URGENT - FIELD SAFETY NOTICE

IntelliVue MX40

Increased Battery Power Consumption and Absence of Low Battery Alerts

Device Info Screen

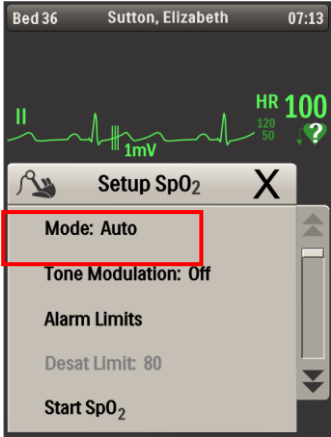
Revision B software

Confirm Revision B software
